Replacement window details
Scale 1:5@A1
1:10@A3

Rev:				Client:			
A	Comments: Amendments as clouded.	By: KN	Date: Nov 25	Mr. Simon Dougall			
Project Title:				Drawing Title:			
107 High St, Lindfield, Haywards Heath, West Sussex, RH16 2HR				Replacement casement window - first floor south east elevation			
Scale:				Date:			
1:25@A1 1:5@A1 1:50@A3 1:10@A3				Apr 25			
Drawn:				Checked:			
KN				KW			
Project No.:				Drawing No.:			
900-25				5023			
Revision:				A

Section

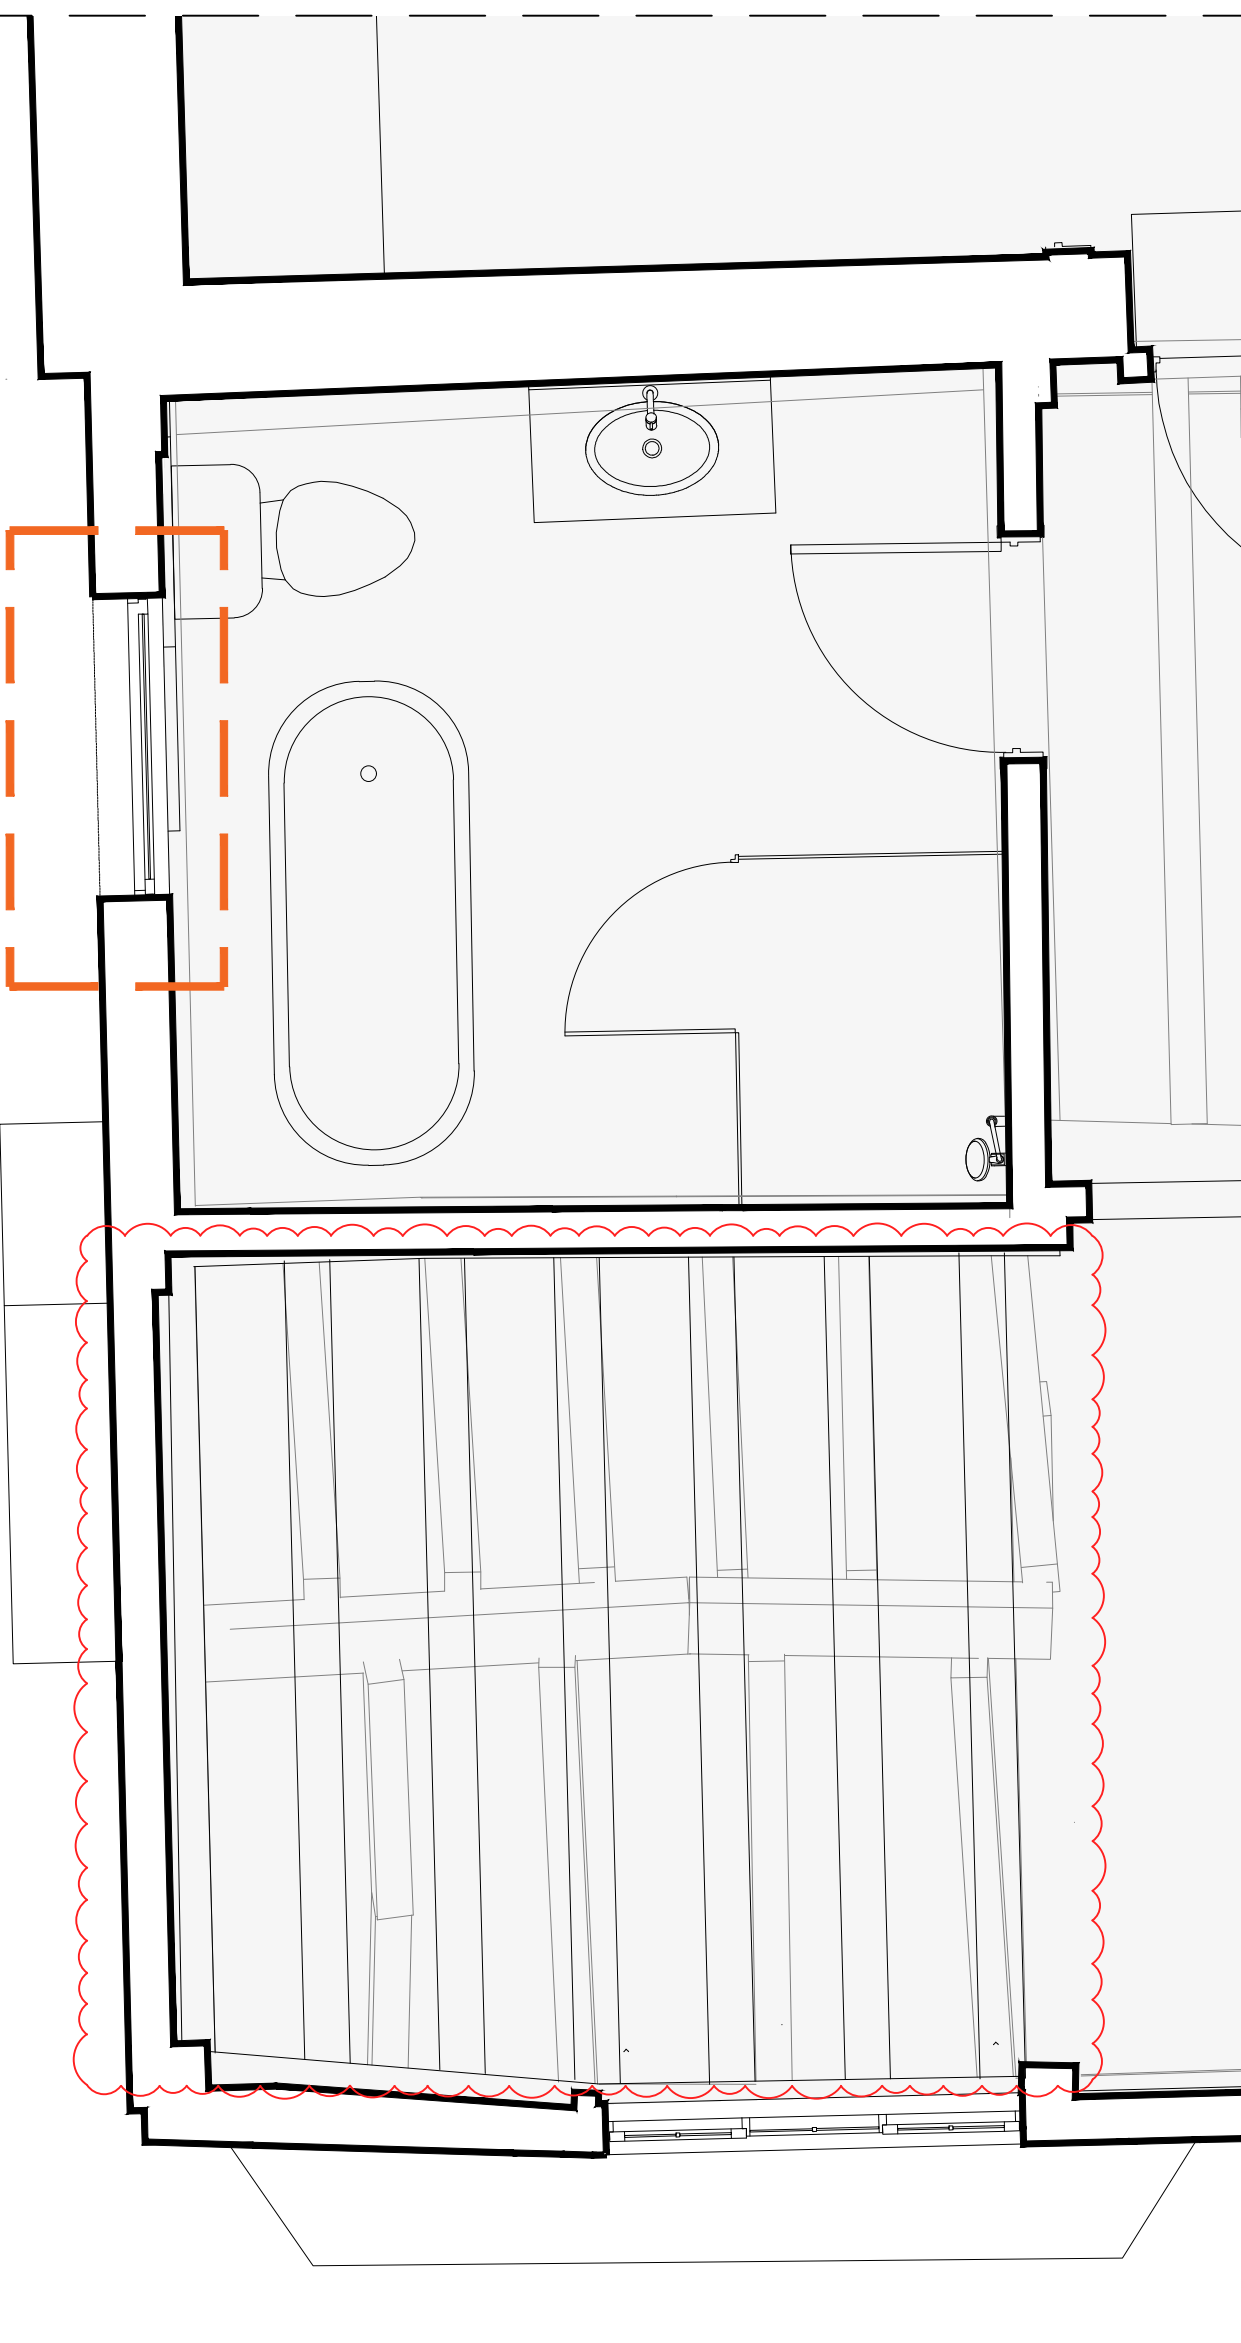
KEY:
Highlighted difference between Approved Scheme and 'As-Built'/Proposed Scheme
